**RESOLUTION HOLDING HEARING ON REQUEST FROM
ELECTRO MANAGEMENT CORP. (PURCHASER) FOR FIRST AMENDMENT TO THE CITY
GATEWAY PUD CONCEPTUAL PLAN ON PROPERTY
LOCATED AT 4240 ARMY POST ROAD**

(ZON2015-00166)

APPROVAL of the proposed 1st Amendment to the PUD Conceptual Plan for "City Gateway" for Electro Management Corporation subject to the following revisions to the Plan:
(ZON2015-00166)

CITY GATEWAY PUD CONCEPTUAL PLAN
DES MOINES, IA
LAYOUT PLAN

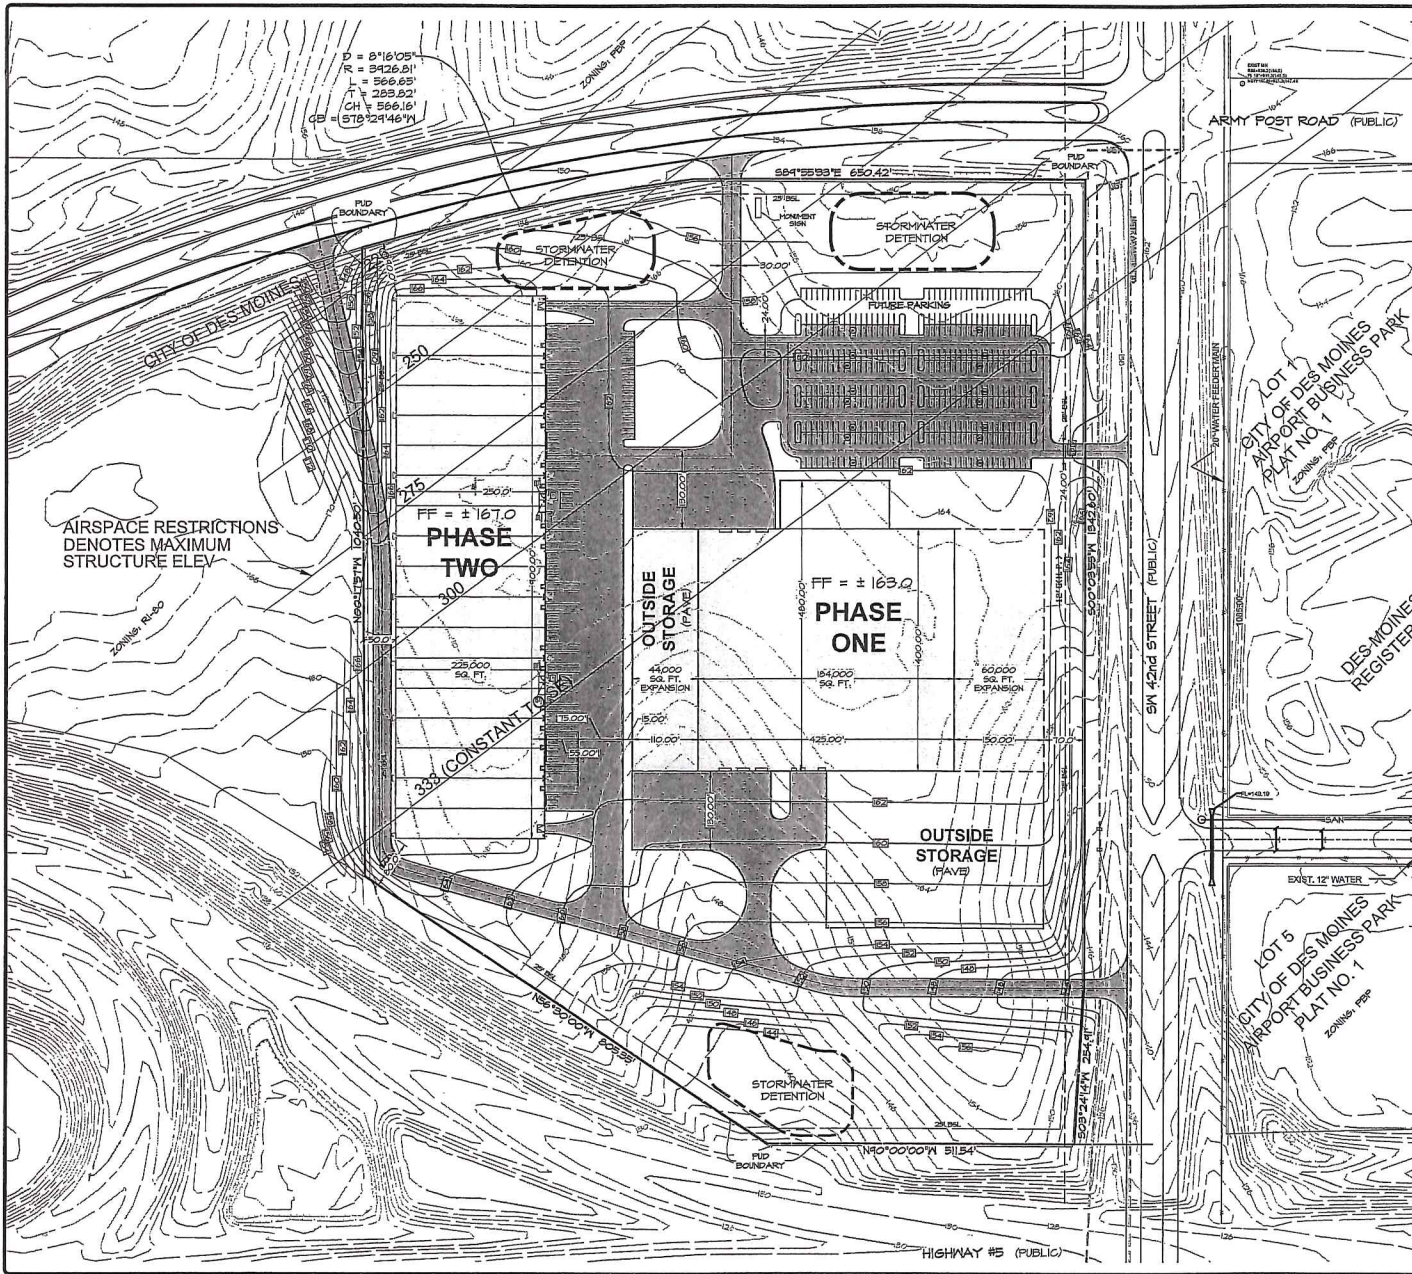
2. Any proposed full access drive entrances shall be reflected on the plan. Only the one drive entrance to Army Post Road may be allowed with full access.

3. Should any driveway from Army Post Road be developed as full access it should be shown and developed with a westbound left turn-in lane constructed in the median and an eastbound right turn-in lane in the Right-of-Way west of the drive entrance, all at the expense of the developer and in accordance with SUDAS requirements. It shall be no closer than 800 feet to Southwest 42nd Street.

8. Flood hazard area and Good Neighbor Task Force references should be removed from the plan.

2. **Flood Hazard Area/Airspace Restrictions:** The submitted plan indicates reference to a Zone A flood hazard area. This should be removed from the plan as there is not any designated flood hazard areas present on the subject property.

The proposed amendment to the PUD Conceptual Plan indicates two drive entrances to Army Post Road and two drive entrances to Southwest 42nd Street. None of the entrances indicate a full access driveway. However, it is presumed that full access will be needed on both streets in order to make necessary traffic movement into and away from the site.

Traffic and transportation indicates that the proposed drive entrance locations are acceptable. However, only one entrance along Army Post Road should be allowed for full access with a median opening. This should be located no closer than 800 feet to Southwest 42nd Street, which is a fully signalized intersection. When any such full access drive would be constructed, it should provide separate eastbound deceleration right turn-in lane and a west bound left turn-in lane in accordance with SUDAS requirements at the developer's expense. Any full access drives will require modification to the public street and must be in accordance with a private construction contract approved by the City Council.

The proposed plan indicates the need for the northwest drive entrance and its grading limit to encroach over into the City owned property controlled by the Des Moines Airport. Engineering representatives of the Des Moines Airport Authority indicate the willingness to lease the necessary area for this entrance. Any sale of the property would require further review and approval by the FAA as it was acquired for purposed of the airport development.

2. Any proposed full access drive entrances shall be reflected on the plan. Only the one drive entrance to Army Post Road may be allowed with full access.

3. Should any driveway from Army Post Road be developed as full access it should be shown and developed with a westbound left turn-in lane constructed in the median and an eastbound right turn-in lane in the Right-of-Way west of the drive entrance, all at the expense of the developer and in accordance with SUDAS requirements. It shall be no closer than 800 feet to Southwest 42nd Street.

8. Flood hazard area and Good Neighbor Task Force references should be removed from the plan.

CITY GATEWAY PUD CONCEPTUAL PLAN
DES. MOINES, IA
EXTERIOR ELEVATIONS

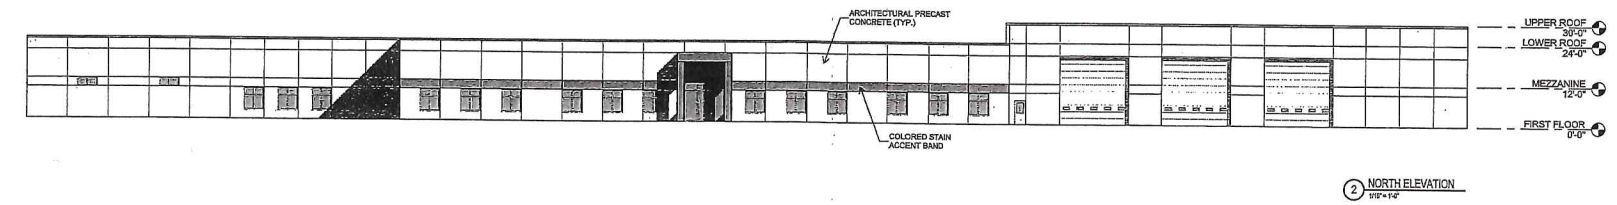
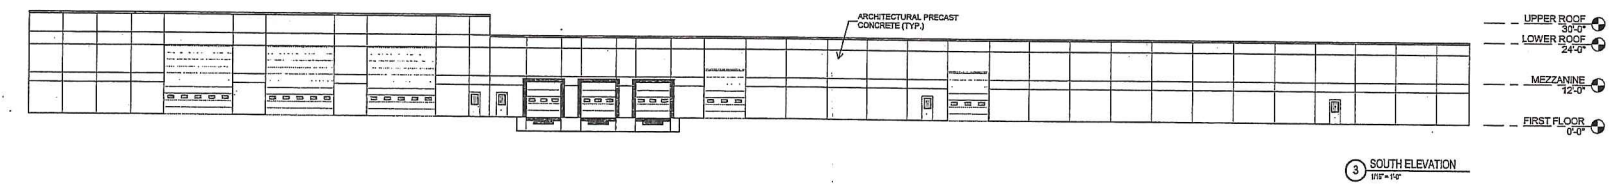
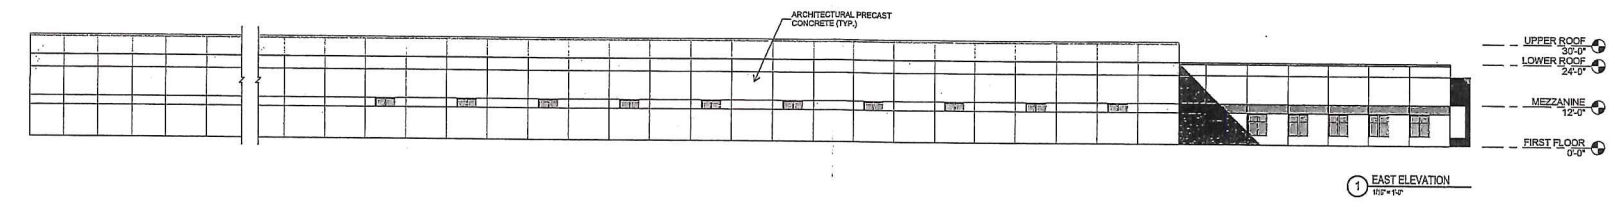
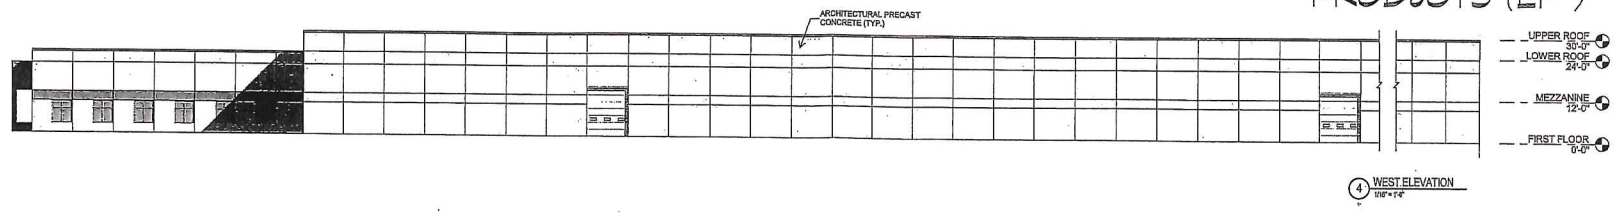
decorative architectural feature. Material innovation and progressive structural design are encouraged when permanency and structural building strength are a result.” The current plan also prohibits the following exterior materials: Plywood, composite siding, composite panels (metal-faced plywood or woodcore), pre-engineered metal with exposed fasteners, metal siding, all plastics (except signs), non-decorative concrete block except where not visible from public views, and EIFS/stucco except for decorative architectural features. Staff believes that these design guidelines are still valid and should be carried over to the proposed amendment. All colors are to be muted or earthtones, with all concrete block or concrete panels required to be painted. These standards should be maintained and added to any approved amendment. Staff believes that the proposed phase 1 building elevations would comply with these standards.

5. Provide requirements for Building Design Standards, Prohibited Materials, and Colors as contained in the current approved City Gateway Plan.
6. Add a note that Phase 2 and any subsequent phases of the Plan shall necessitate a future PUD Conceptual Plan amendment review of the building elevations.
